Addendum #2

Project Name:	East 8th Street Engineering Design and Construction Administration Services
RFP Number:	FA19-06-056
Date:	June 27, 2019
Project Manager:	Brian Ward

Water and Sewer Comments

Figure 3-1. Modified Minor Storm Spread Criteria

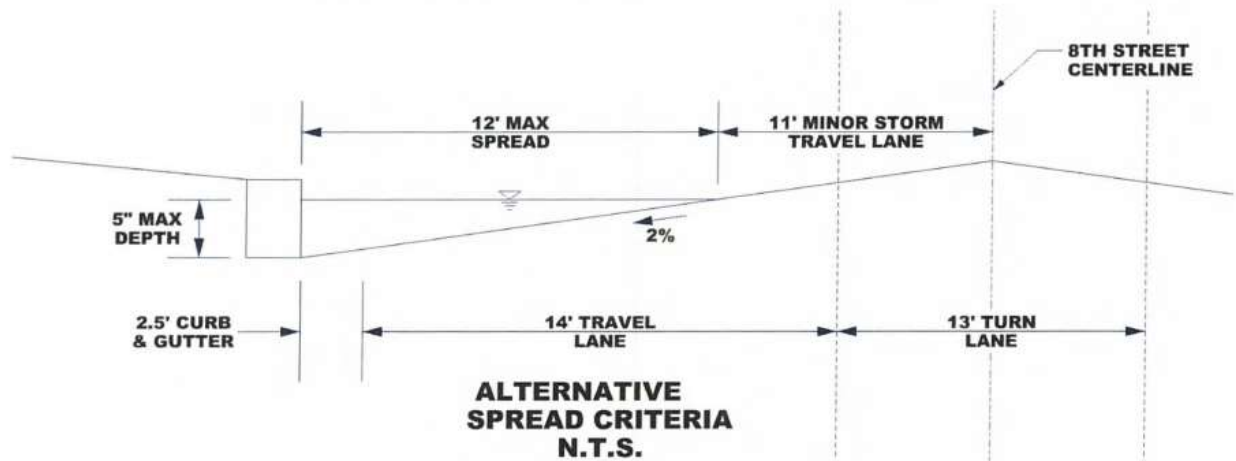
1. Sheet 96: Please add to the contact list City of Greeley/Stormwater/ ‘null’/ Karen Pryor/ 970-336-4031/ karen.reynolds@greeleygov.com
2. Sheet 67 (and see ‘Drainage Report ‘Culvert Designer/Analyzer report A21) Culvert A21, 24” RCP @ 0.2% w/ 10.99 ft/s discharge - City Specs allow for up to 12.0 ft/s but this is very high and 10.99 ft/s will require considerable scour protection. Please consider upsizing pipe to reduce peak velocities. See also next comment on protection.
3. All culverts with velocities greater than 5 ft/s at discharge need permanent scour mitigation designed to mitigate the velocities shown in design calculations & proposed soil conditions at inverts. Please identify these locations on the plan sheets and include the calculations in the design report.
